Service Bulletin Car Stereo

Model: XR-130, XR-150

No. 406

Subject: PREVENTING THE NOSE SWITCH FROM

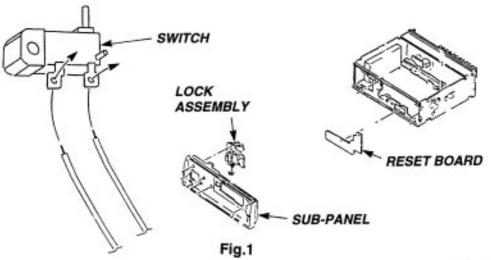
(111) SW303 (NOSE DETECT SWITCH) may become damaged, which does not allow the

unit to turn on.

Replace the switch and front back panel with a new improved one. The parts you will need are listed in the table below.

Fig.3

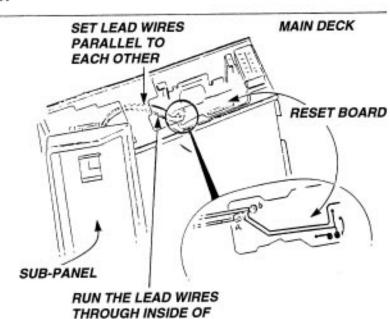
- 1- Remove the sub panel
- 2- Remove SW303 (Nose Detect Switch) on reset board.
- 3- Prepare 2 Lead wires (90mm long).
- 4- Solder the 2 Lead wires to the new switch as shown. (fig.1)
- 5- Mount the switch onto the lock assembly using the P2 x 5 screw as shown. (fig.2)
- 6. Solder the Lead wires of the switch to the holes of the reset board, where switch was originally soldered. Polarity of wires is not important. (fig.3)
- 7. Replace the back of the front panel with the new one indicated in the parts table above.

THROUGH INSIDE OF THE CHASSIS SOLDER TO RESET BOARD
